APPENDIX C: REVISED OFFSITE DOSE CALCULATION MANUAL

LICENSING CHANGE REQUEST

LCR 91-1104-0DM

A) Document Offsite Dose Calculation Manual

Figure 10.0-2
SAMPLING LOCATIONS
BY STATION NUMBER
(GREATER THAN 10 MILES)

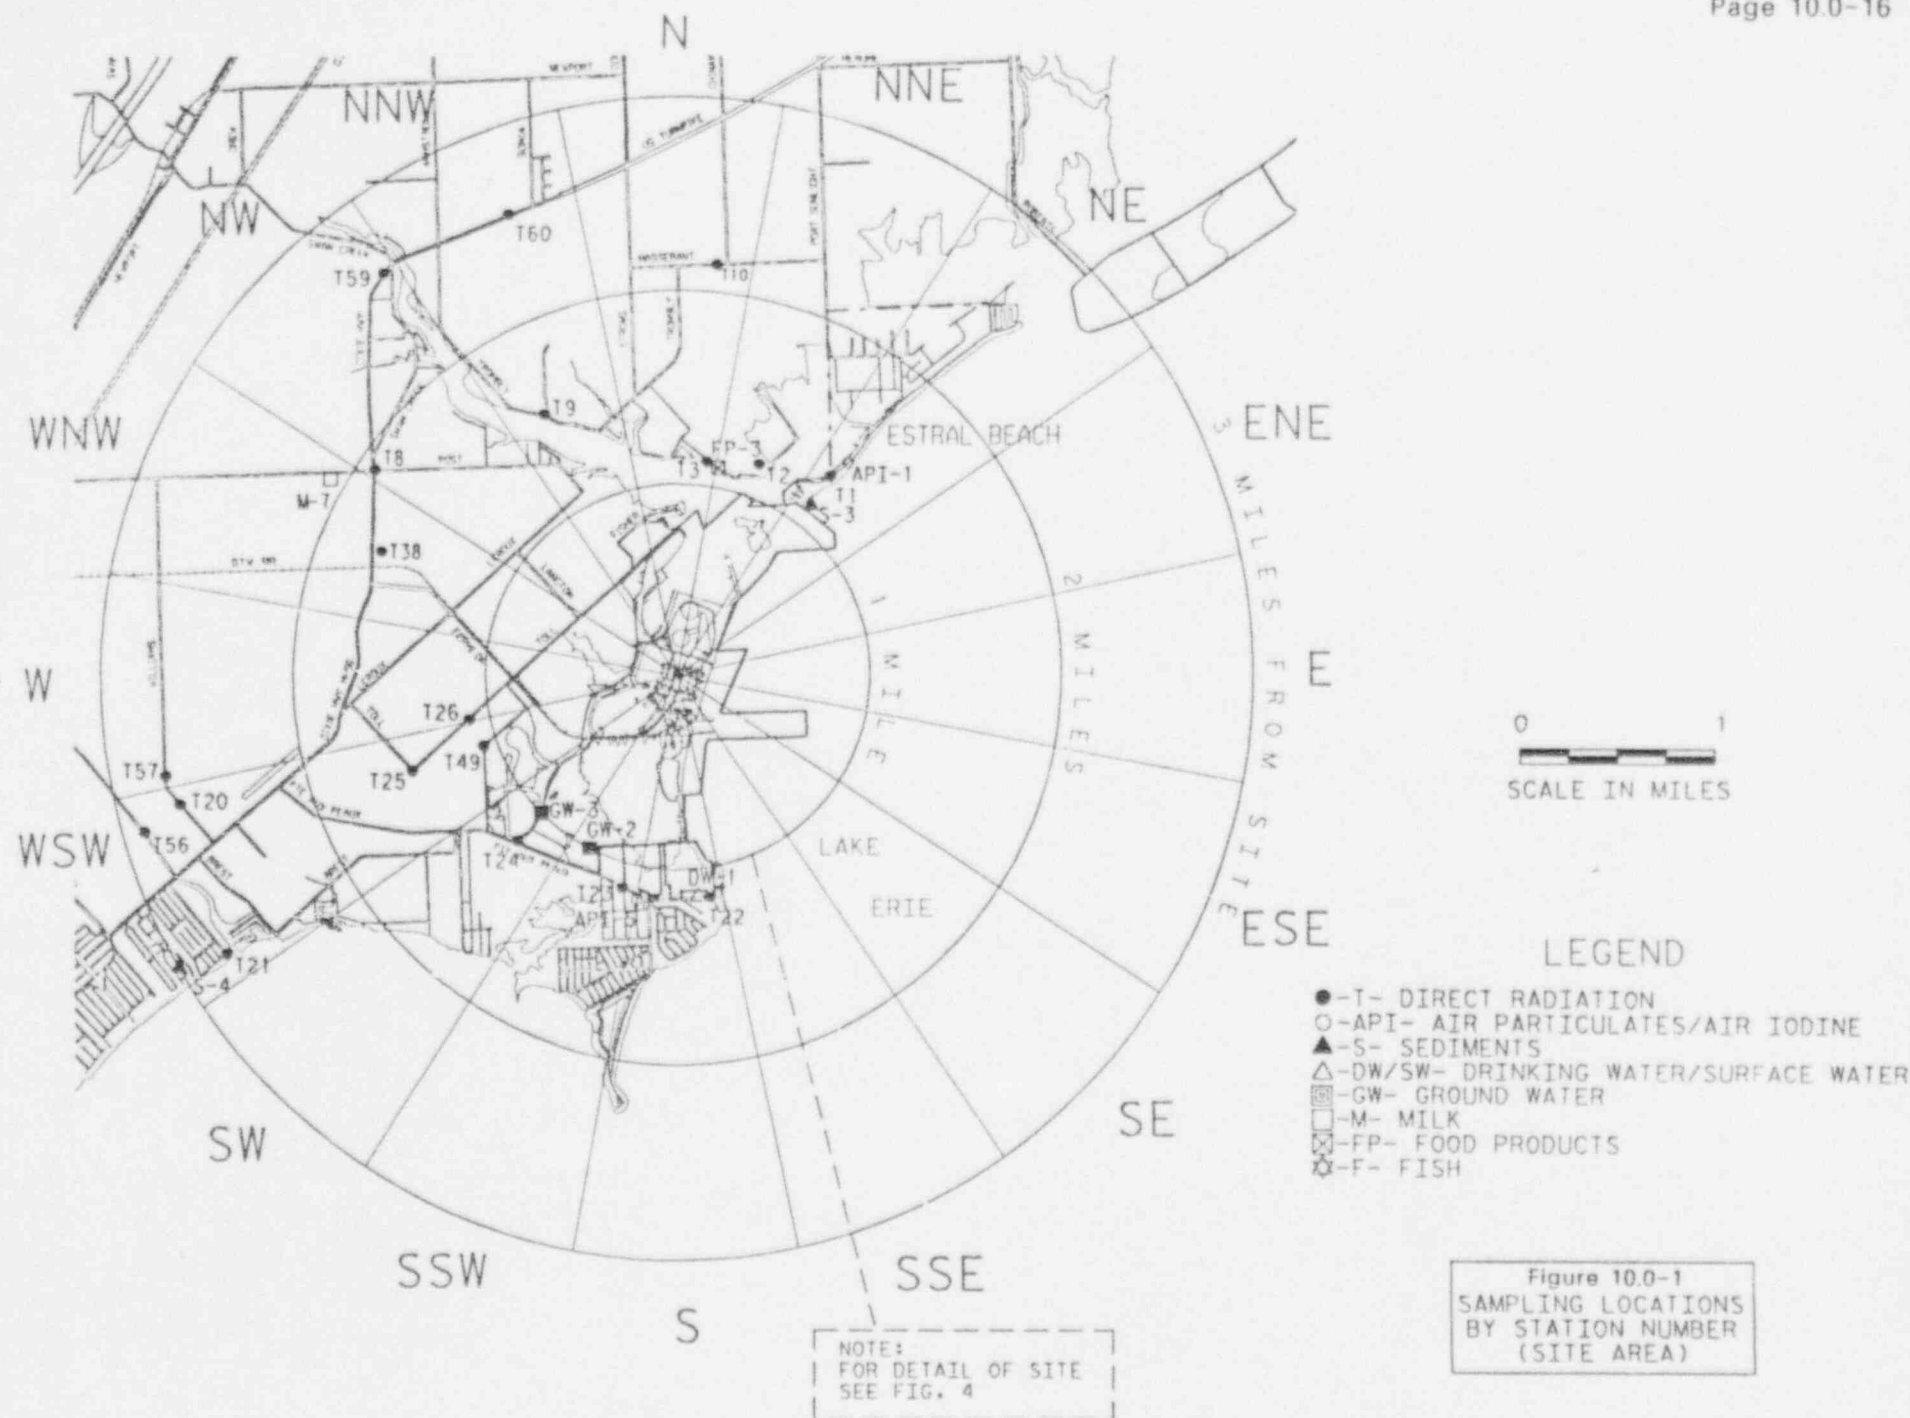
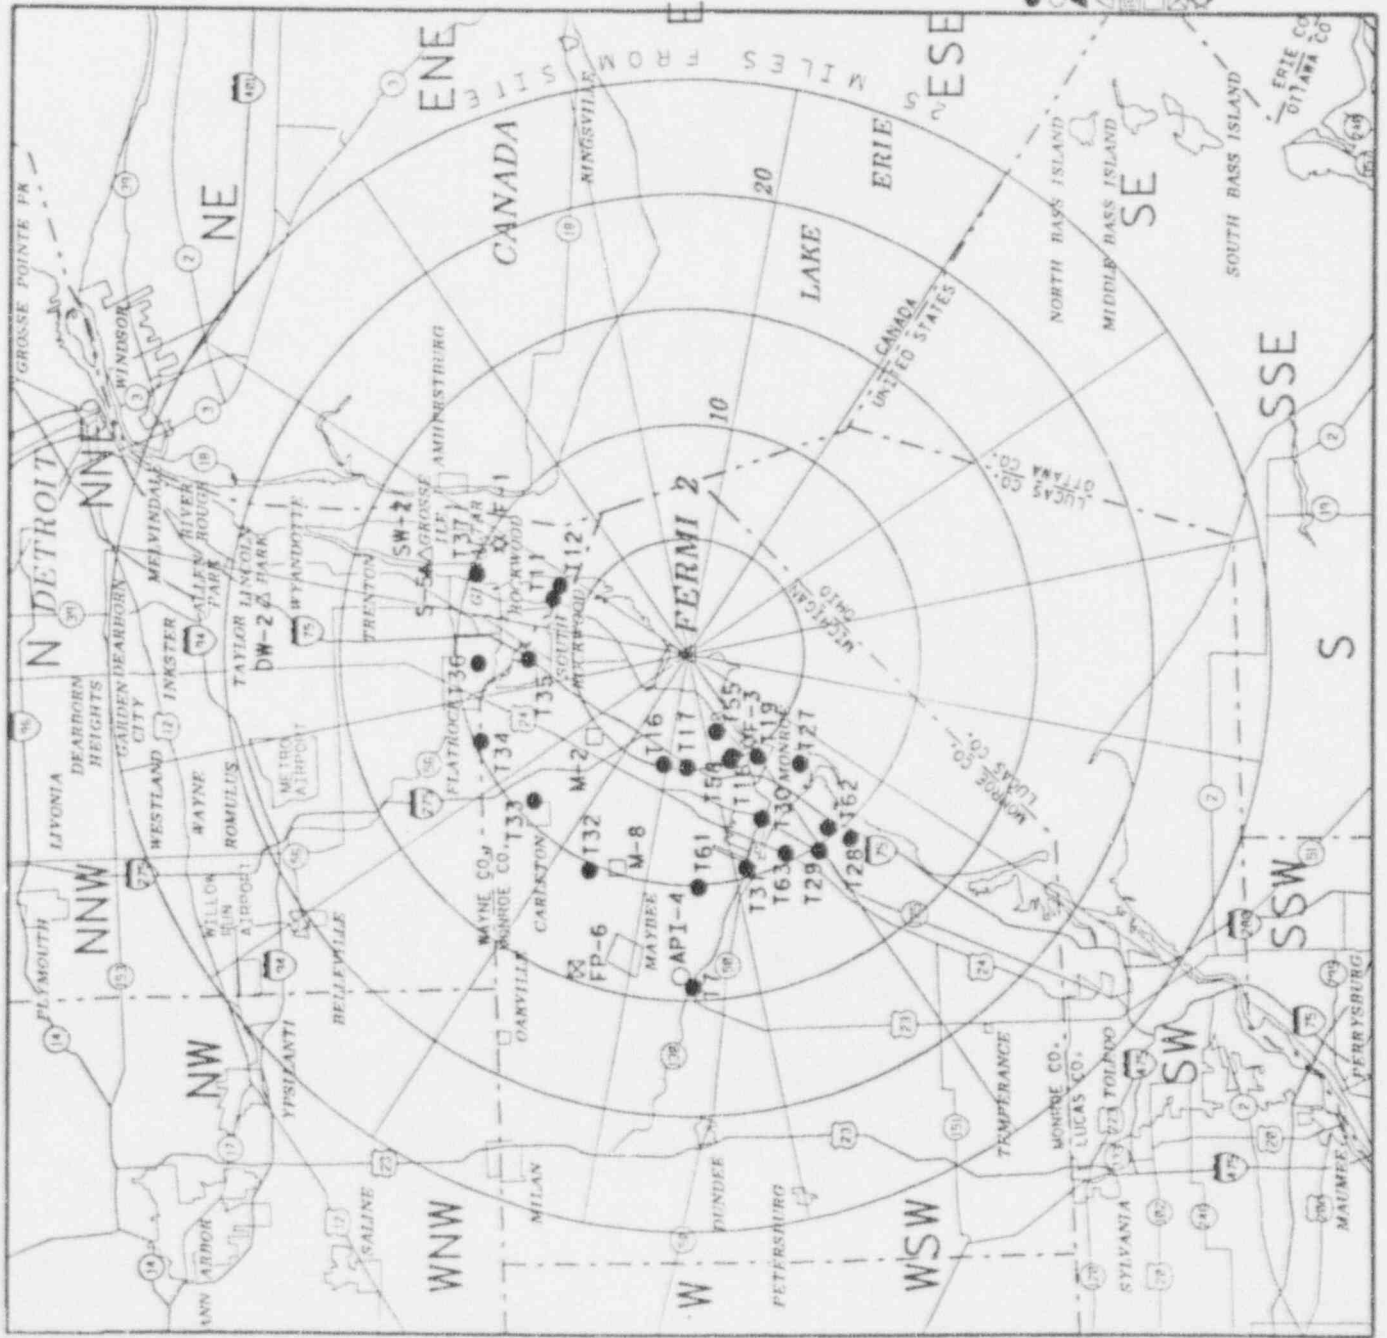
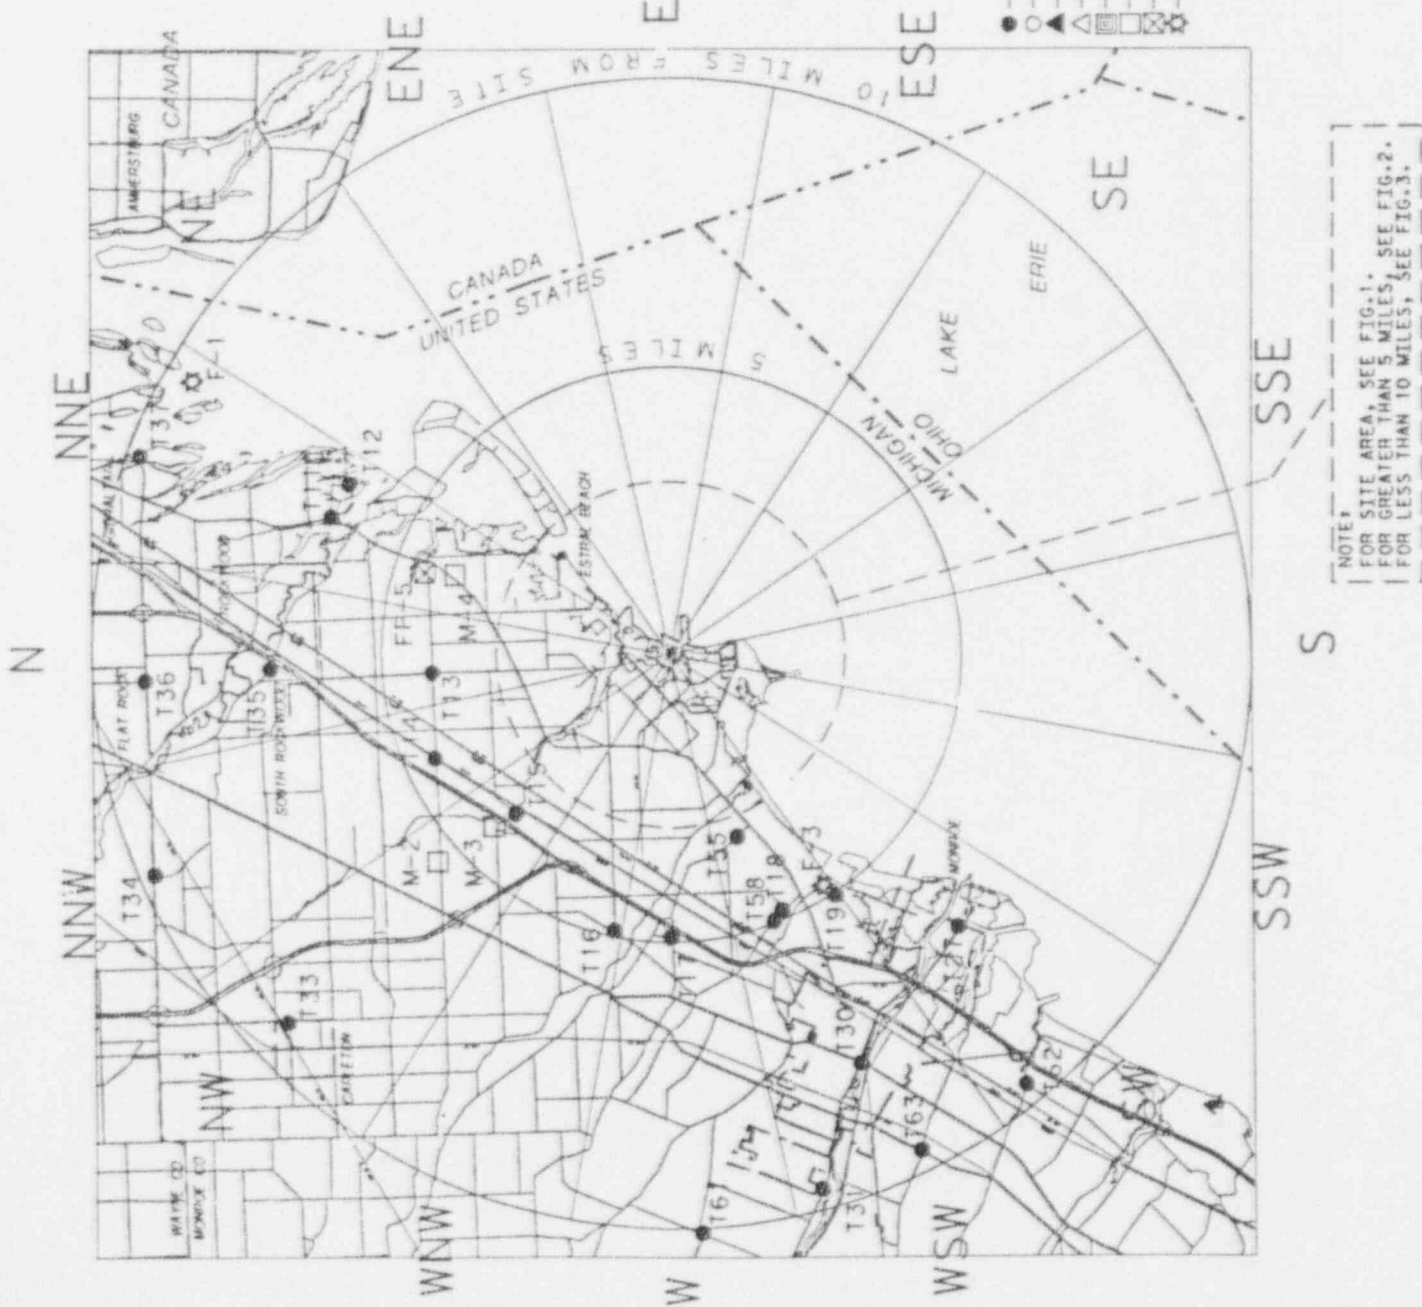
10.1 NOTE / 10.0-1 (formerly 6.1 NOTE / 6.0-1)	Add section allowing sampling locations to be changed for reasons other than land use causes findings and state where changes are to be reported and how they are to be evaluated.	Many contingencies may necessitate changing sampling locations - provides needed flexibility while ensuring evaluation if change could affect identity of critical receptor.
Table 10.0-1 / 10.0-4 (formerly Table 6.0-1 / 6.0-4)	Change location of TLD # T 11; correct description of TLD locations T2, T8, T24, and T30	High vandalism rate necessitated relocation; REMP audit noted incorrect location descriptions
Table 10.0-1 / 10.0-7 (formerly Table 6.0-1 after 6.0-6)	Added 17 TLD locations (new page)	Provide better coverage of area.
